**CITY OF NORTH ST. PAUL PLANNING COMMISSION  
REGULAR MEETING AGENDA  
THURSDAY, AUGUST 13TH, 2020  
6:15 PM**

Date: 8/11/2020  
To: Planning Commissioners  
From: Erin Perdu, AICP, City Planner  
Morgan Dawley, PE, City Engineer  
CC: Scott Duddeck, City Manager  
Re: Preliminary/Final Planned Unit Development, Site Plan Review and Preliminary/Final Plat for development of 12 townhouse units at the Intersection of Delaware Avenue and 17<sup>th</sup> Avenue (2329 17<sup>th</sup> Avenue E).

Paul Bruggeman is requesting approval of a Preliminary/Final Planned Unit Development (PUD), Site Plan, and a Preliminary/Final Plat to facilitate the development of a revised concept (October 2019) for 12 townhouse units at 2329 17th Avenue E. The subject site is a vacant, City-owned, 2.48-acre parcel.

522 | DRAINTILE TRENCH  
NOT TO SCALE

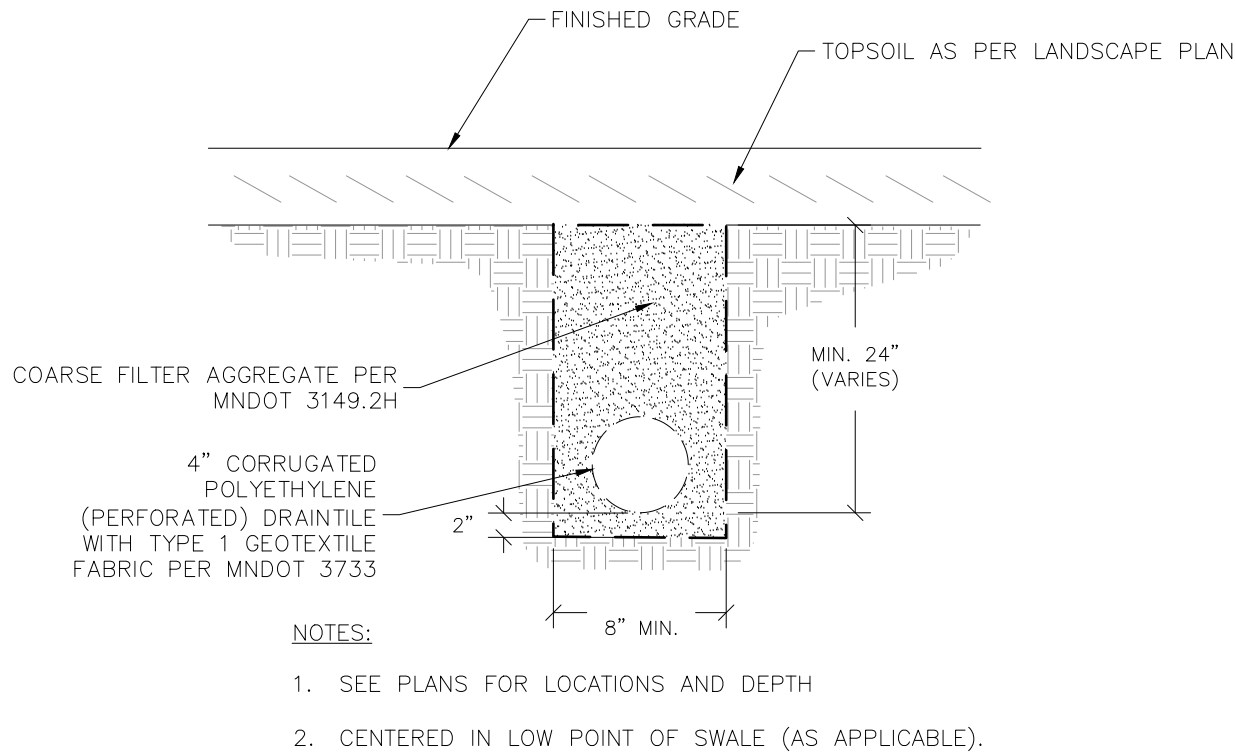
21. Draintile is noted on the applicant's 8/6/2020 response memo as having been review, but there is still a detail for draintile. Clarify on revised submittals.
